YEAR  
1991

MODEL  
LEGEND  
COUPE

BULLETIN NO.  
91-039

## Popping Noise from the Front Window Regulator

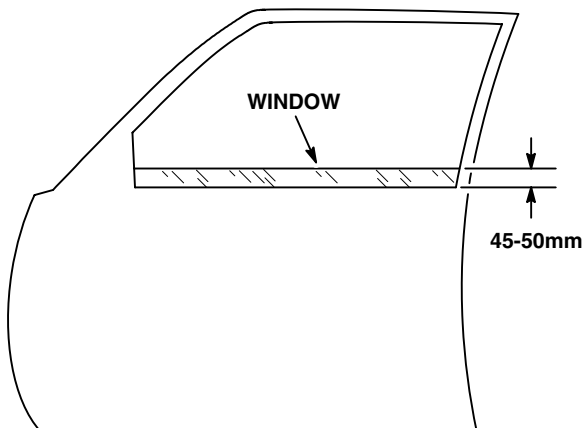
A popping noise coming from the front door when the window is raised.

A plastic washer on the window regulator obstructs the regulator movement. When the regulator overcomes the washer's resistance it makes a popping noise.

Remove the plastic washer from the window regulator as follows:

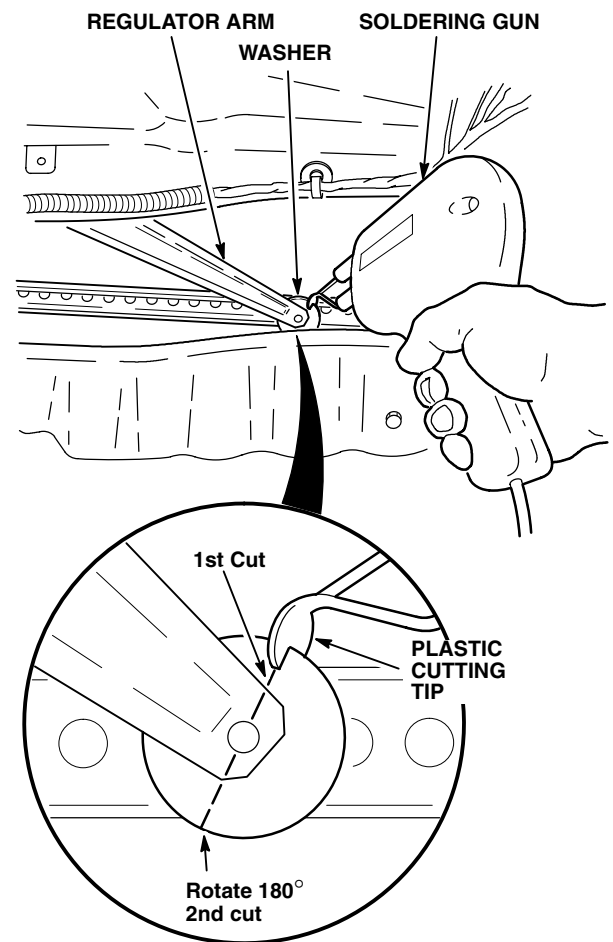
3. Using a soldering gun with a plastic cutting tip, make a cut through the washer on the regulator arm as shown.

Use care when cutting the washer to not damage the slider with the plastic cutting tip.

4. Rotate the washer 180° and make another cut through the washer with the plastic cutting tip. Remove the washer from the regulator.
5. Lubricate the sliding surfaces of the window regulator with grease.
6. Reconnect the door panel switches and check the power window, door lock and security system for operation. Once all operations are checked, reinstall the door panel.
